Product changes 2019

MAY 2019

WP6874

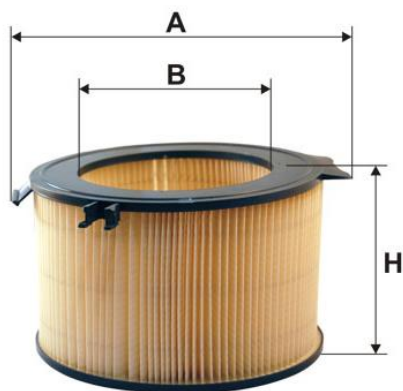
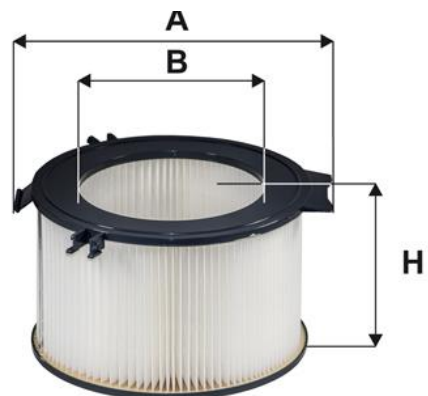
The filter medium has been changed to adapt to the current OE version.

WP9026

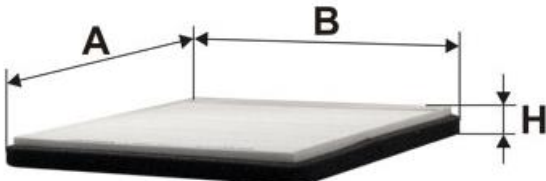
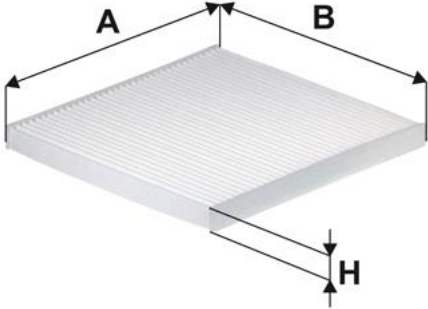
Change of the sealing method to adapt to the current OE version.

WP9174

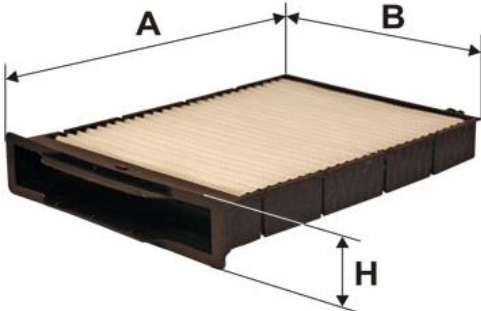
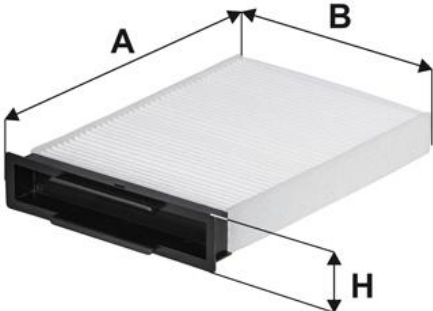
Change of the design to facilitate the filter installation.

WP2010

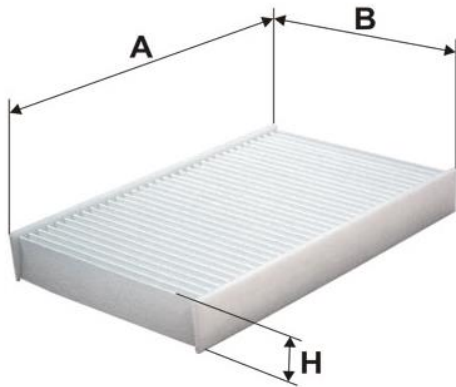
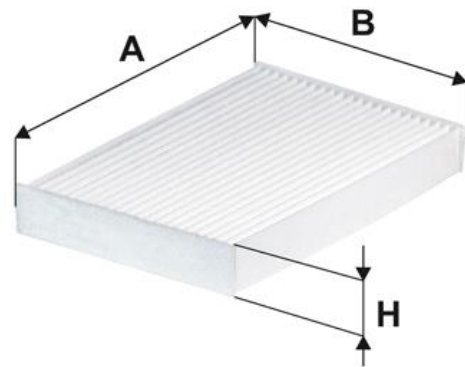
The pleats have been turned by 90 degrees to facilitate the filter installation.

93237E

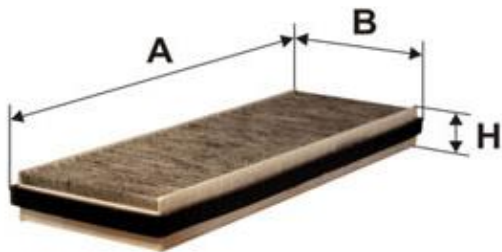
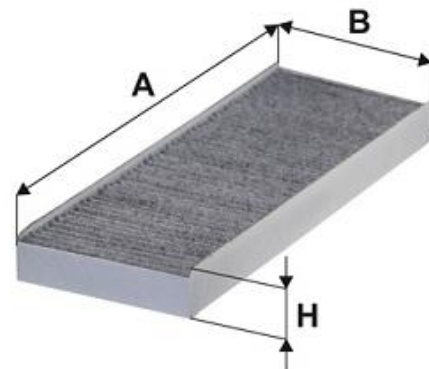
Change of the sealing method to adapt to the current OE version.

WL7021

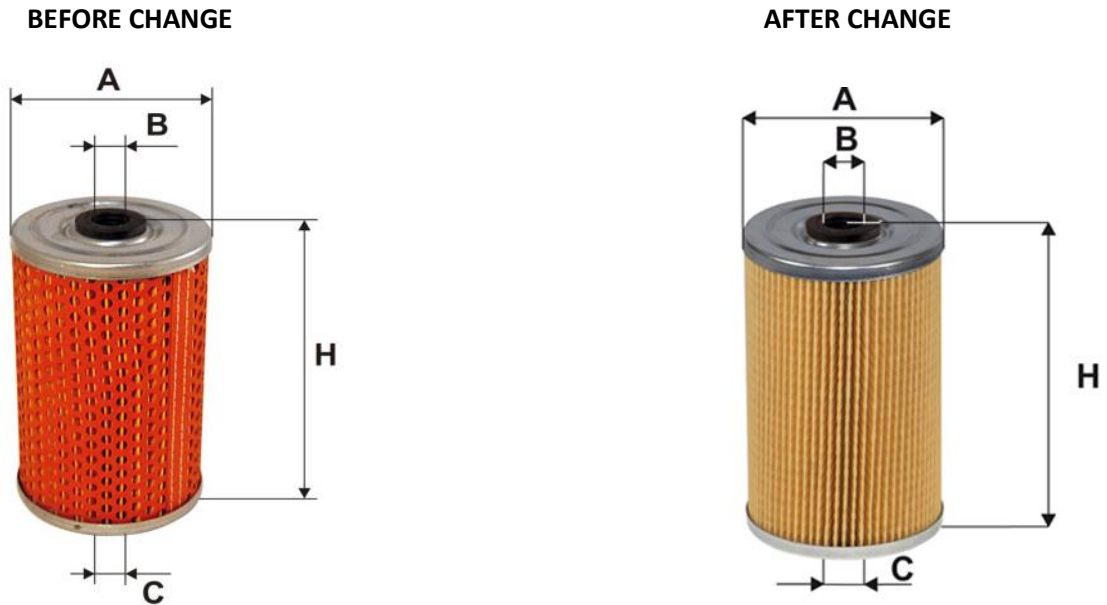
The covering paper has been removed.
